**Pipeline and
Hazardous Materials
Safety Administration**

On December 2, 2004 I requested that you review French Certificate of Approval No. F/379/B(U)F-96 for the TN 106 package, and make a recommendation concerning our revalidation of the package for import and export use. As a result of your ongoing review, your office issued a Request for Additional Information (RAI), which I relayed to our applicant, Packaging Technology, Inc., on September 22, 2005. The applicant has since responded to the RAI.

TN106 US Revalidation
22-Sept-05 RAI Responses

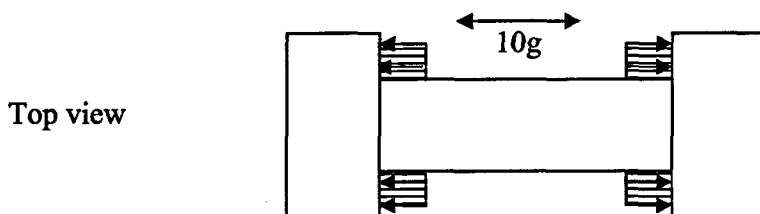
1: Provide justification for the tie-down attachments and handling devices acceleration factors used. These factors are not as recommended in IAEA Safety Guide No. TS-G-1.1 (ST-2).

The trunnions will not be the tie-down attachments for transport in the US as they are not designed for the acceleration factors recommended for the US in table V.2 in IAEA Safety Guide No. TS-G-1.1. A transport skid which cradles the package shell will be designed for transport in the US with the condition that longitudinal load (mass accelerated to 10g) is applied on the shock absorbers as shown by the following sketch:

The load will act directly on the balsa compartment of the shock absorbers but without crushing it (the level of compression stress is much lower than the balsa crushing stress given at around 10 MPa according to paragraph 6.6.1 of chapter 5573-Z-0 and also the steel crushing stress). It is first checked that the medium plate (item 506) of thickness 12 mm under bolt will not get sheared.

Maximal accelerated mass of the TN 106 packaging = $12\,345\text{ kg} \times 10\text{ g} = 1,21 \cdot 10^6\text{ N}$

Shearing section (diameter 820 mm / thickness 12 mm) = $3,09 \cdot 10^4\text{ mm}^2$

Shearing stress = 39 MPa

This value is much lower than the allowable value (0,6 times the yield stress of the plate steel): the plate will then resist to the load.

Consequently the load will be transmitted to the bolts of the shock absorbers which constitute the only attachment points. Then it is checked that the load will not induce too excessive tensile stress in the bolt.

PICTURE 1
EXPERIMENTAL EQUIPMENT (front view)

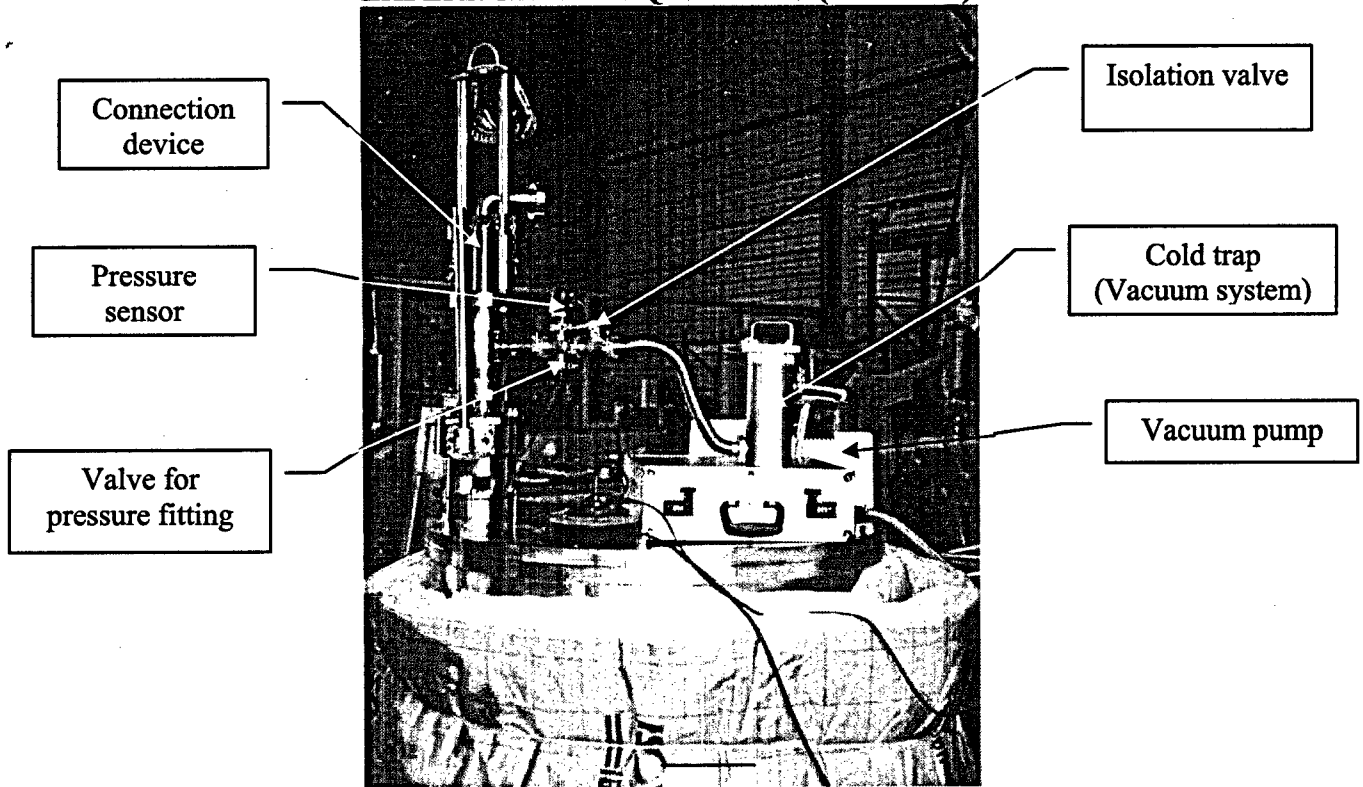
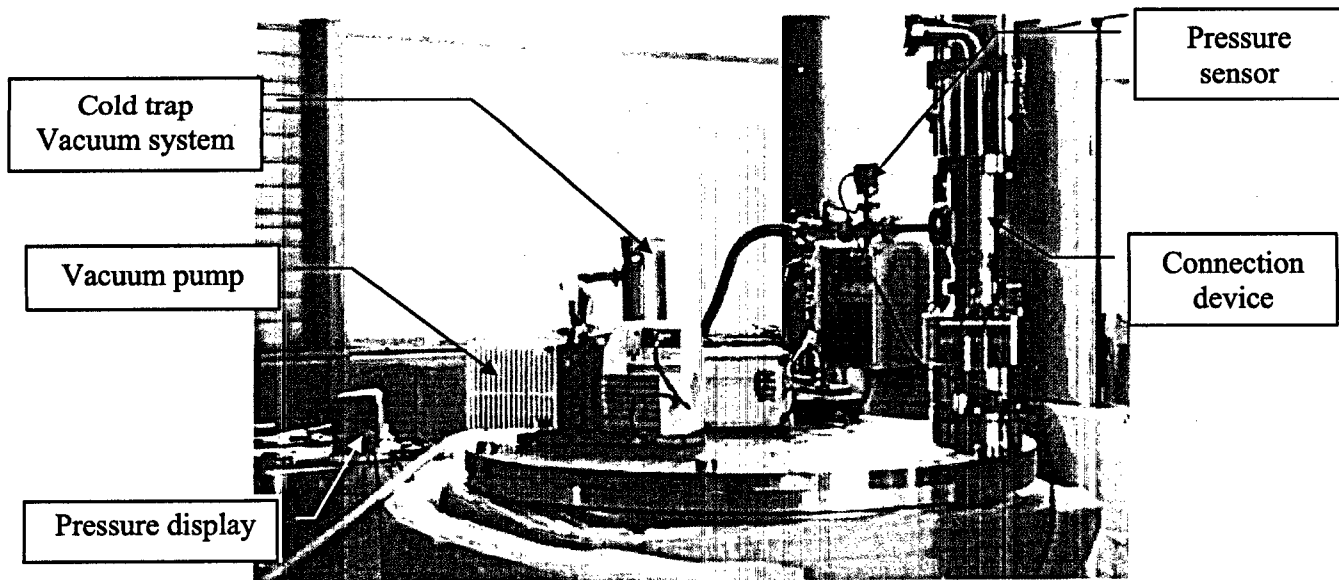
8 : Provide evidence that the proposed drying procedure “the pressure is dropped between 6 and 10 mbars and held with no more than 1 mbar rise over a 5 minute period” will actually result in drying the package cavity.

COGEMA LOGISTICS has already performed a validation test of this procedure. The test consisted of a complete drying test of a cavity with existing experimental equipment in the most severe operations conditions, and with controls for the drying criterion. The package was cylindrical with a cavity of diameter 960 mm and length 1080 mm with a metallic basket inside.

- Assembly and fitting of the experimental equipment (see pictures 1 and 2)
- Filling with water followed by draining of the cavity
- First period of drying (about 3h30)
- First drying test (see table 1): the result is 10 times higher than the criterion
- Restart of the drying

- Following drying tests, until the criterion is reached (see table 1): four steps of measurement - drying were needed to reach the criterion
- Opening of the container and visual inspection of the basket, the cavity : All the accessible areas of the basket and of the cavity are completely dry. No wiping have been needed because no water was visible, included in condensate form.

In conclusion, even in the most difficult conditions, without any internal thermal power, this test shows that all accessible areas of the cavity are completely dry as soon as the criterion of the control of the drying is reached.

Figure 1. Explicit 21x21 Pin Model

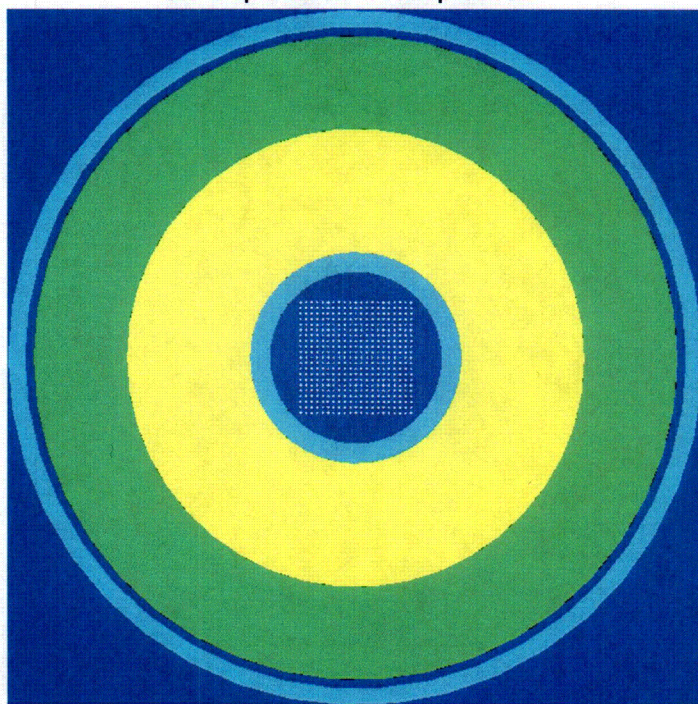
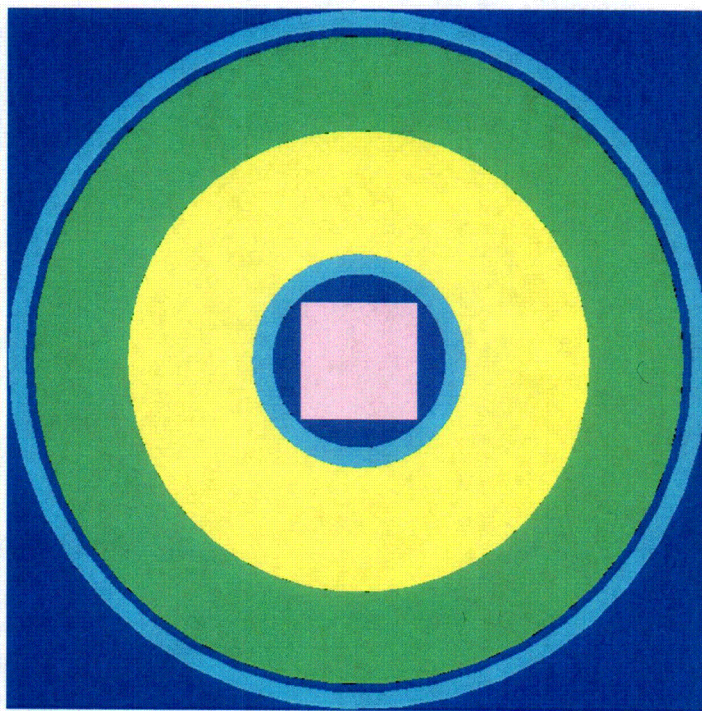
2: Provide justification for the use of lattice cross-sections with homogenized geometry. Section 5.2 of attachment 6 states that in order to simplify the calculations cell weighted cross-sections were generated considering heterogeneous fuel pellets and moderator and these cross sections were then applied to a homogeneous fuel/moderator volume. Further explanation is needed to determine the implications of this simplification.

To simplify the comparison, the explicit pin array is modeled as the largest square array (21x21) which will fit inside the cylindrical cavity of diameter 20.3 cm, see Figure 1. Note that this results in radial water gaps in the cavity and a loss of fuel mass when compared to the base case. The equivalent case is modeled using the homogenized "material 500" approach, see Figure 2. The results are as follows:

21x21 pin array, explicit:	$k = 0.7883 \pm 0.0005$, $k_s = 0.7893$
21x21 pin array, homogenized:	$k = 0.7900 \pm 0.0005$, $k_s = 0.7910$

The homogenized method results in a 1.7 milli-k (mk) increase in reactivity when compared to the explicit method, which is within the expected statistical fluctuation. The two methods are therefore statistically equivalent. The reactivity is significantly lower than the base case (0.9223) simply because the mass has been reduced.
